UNITED STATES PATENT AND TRADEMARK OFFICE

APPLICATION NO.	FILING DATE	FIRST NAMED INVENTOR	ATTORNEY DOCKET NO.	CONFIRMATION NO.
10/696,990	10/30/2003	Jason A. Demers	1062/D85	7851

Office Action Summary

DETAILED ACTION

Fig. 1

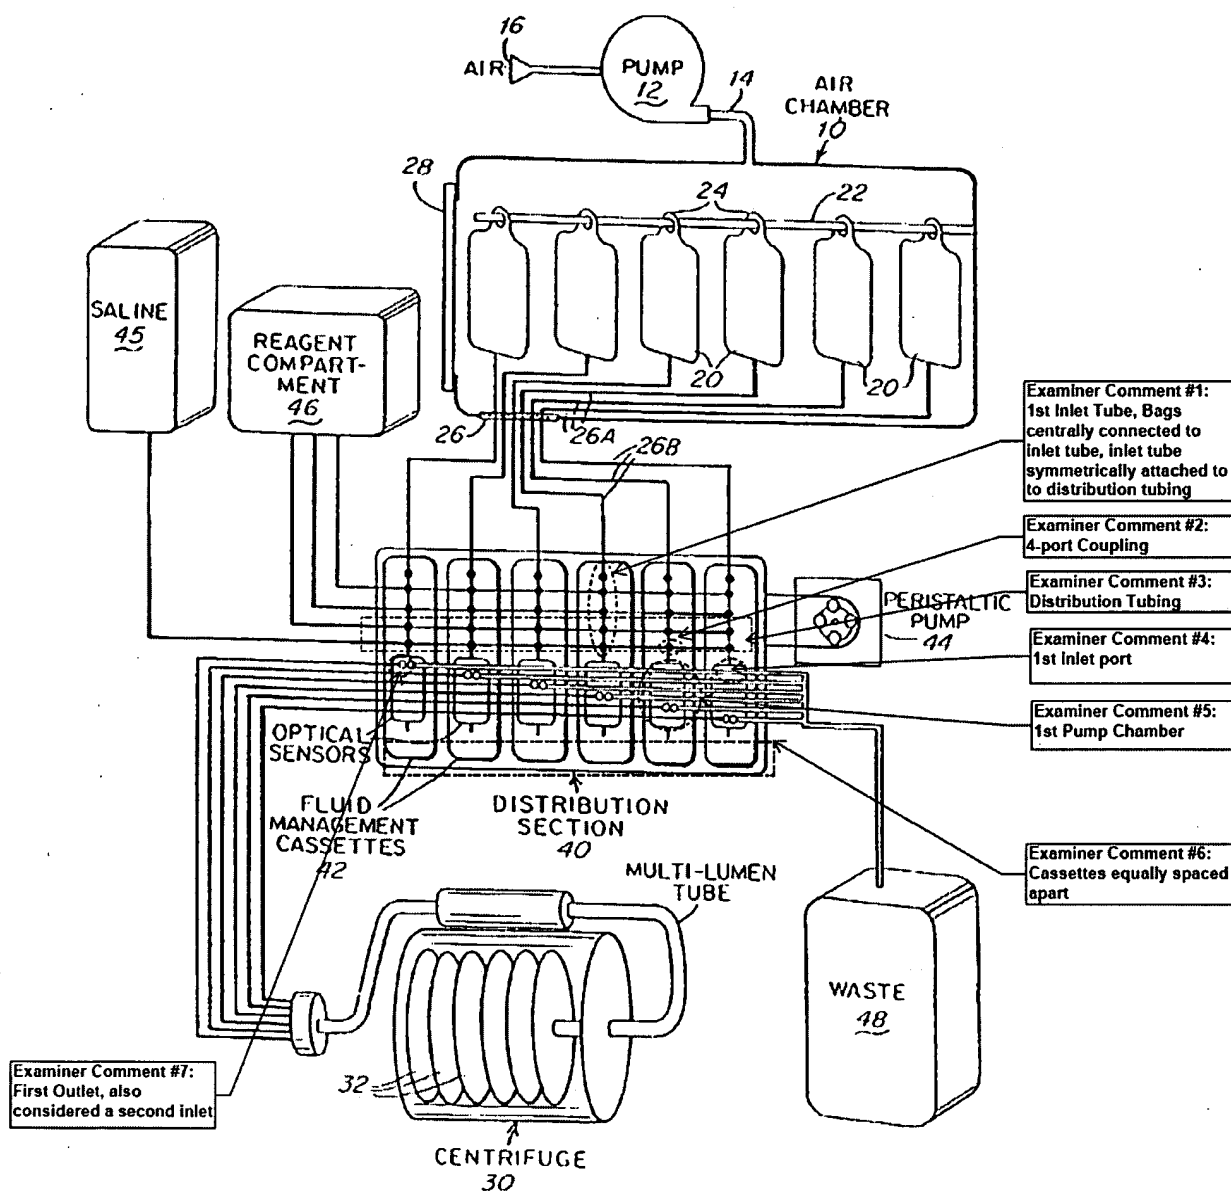
3. Claims 1-4, 8, and 23-25 are rejected under 35 U.S.C. 102(a) as being anticipated by Rosiello 7,011,742. Rosiello '742 teaches the invention as substantially claimed including an apparatus for use in a fluid processing workstation having a plurality of pumps, and further comprising: a plurality of pump cassettes 42 for use respectively with the plurality of pumps, 12 and 44, each cassette having a first fluid inlet port (comment #4 on Fig. 1) in selective fluid communication with a first pump chamber (comment #5 on Fig. 1), an inlet tube (comment #1 on Fig. 1), and distribution tubing (comment #3 on Fig.1) that connects the inlet tube to the

first fluid inlet port of each of the pump cassettes 42; an inlet tube centrally attached along the distribution tubing and the plurality of pump cassettes 42 are symmetrically attached to the distribution tubing with respect to the inlet tube attachment (comment #1 on Fig. 1); attachments of the plurality of pump cassettes 42 to the distribution tubing are equally spaced apart along the distribution tubing (comment #6 on Fig. 1); a plurality of incubation bags 32, each bag being attached to an outlet port on a respective one of the pump cassettes (comment #7 on Figure 1); a four-port coupling (comment #2 on Fig. 1) inserted in the distribution tubing such that the distribution tubing extends out from first and second oppositely located ports of the coupling, the first fluid inlet tube is connected to a third port of the coupling and the first fluid inlet port of a middle one of the pump cassettes is coupled to a fourth port of the coupling. Further Rosiello teaches a kit comprising a plurality of pump cassettes 40, each cassette 42 having a first fluid inlet port (comment #4 on Fig. 1) in selective fluid communication with a first pump chamber (comment #5 on Fig. 1), and an inlet tube (comment #1 on Fig. 1) and associated distribution tubing (comment #3 on Fig. 1) for connecting the inlet tube to the first fluid inlet port of each of the pump cassettes 42; and a plurality of incubation bags 32 for attachment respectively to an outlet port (comment #7 on Fig. 1) of each of the pump cassettes 42. Reference is made to Figure 1 of Rosiello, included subsequent to paragraph 2.
